Access Compliance Report

Public Rights-of-Way

(Curb Ramps)

Intersection ID: 45061	Main Street: EVANGELION_CT	Cross Street: REDDING_GLEN_AV	Location: NW
ADA ID: AB9842E9A94F	Ramp Type: BlendTrans1	Initial Pass/Fail: Pass	Overall Compliance: No
Severity Score: 10			
Codes/Mitigation Info/Possible Solution		Field Measurements/Component Compliance

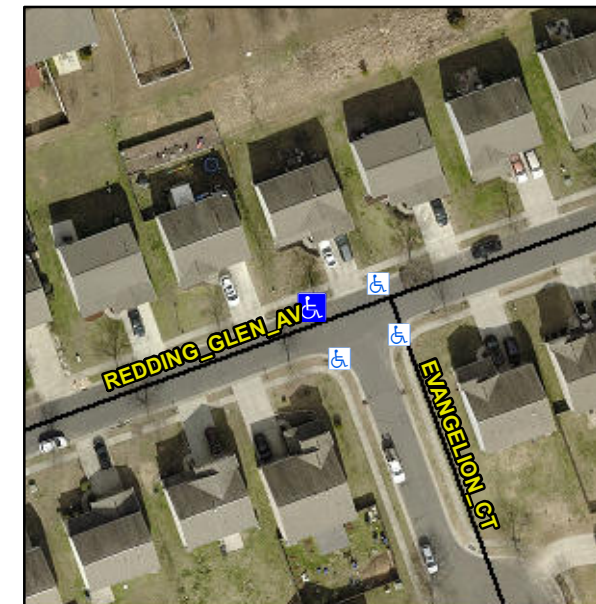
Not Found, R304.2.2-Perp, R304.3.2-Para, R305

N/A	Ramp inside XWalk1?	N/A	N/A	Ramp inside XWalk2?	N/A
	Road Slope (%)	0.9		Clear Space?	Yes
	Road X Slope (%)	4.2	N/A	Clear Space to XWalk (in)	N/A
Yes	Any Obstructions?	No	Yes	Storm Grate/Utility Hazard?	No
	Obstruction Type			Storm Grate/Utility Type	
		N/A			N/A
			Yes	Surface Condition? (G/P)	Good
			No	Curb Slope (%)	14.9

Remove & Replace Curb Ramp With Two New Directional Ramps or Equivalent.
